# SAFETY BULLETIN

Ref Document No.	SB20001	Issue No.	1
Subject	Non-conforming Fuel Shutdown Cylinders		
Release Date	14 <sup>th</sup> August 2020

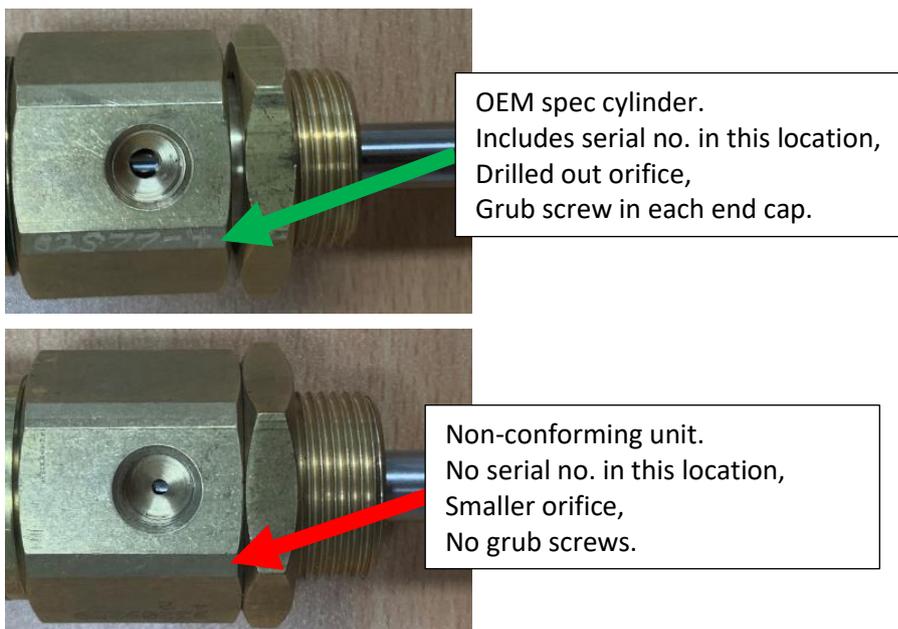
- Port orifice is smaller than OEM spec.
- Spring may be different.
- Missing two grub screws to hold end caps in place.

These non-conformances have safety implications as they may results in differences in the function and performance of the units.

A comparison of the conforming and non-conforming units is shown below:

PPK recommend that any stocked or in-service units which may have been purchased from PPK during the dates specified be inspected to ensure they meet Original Equipment Manufacturer specification.
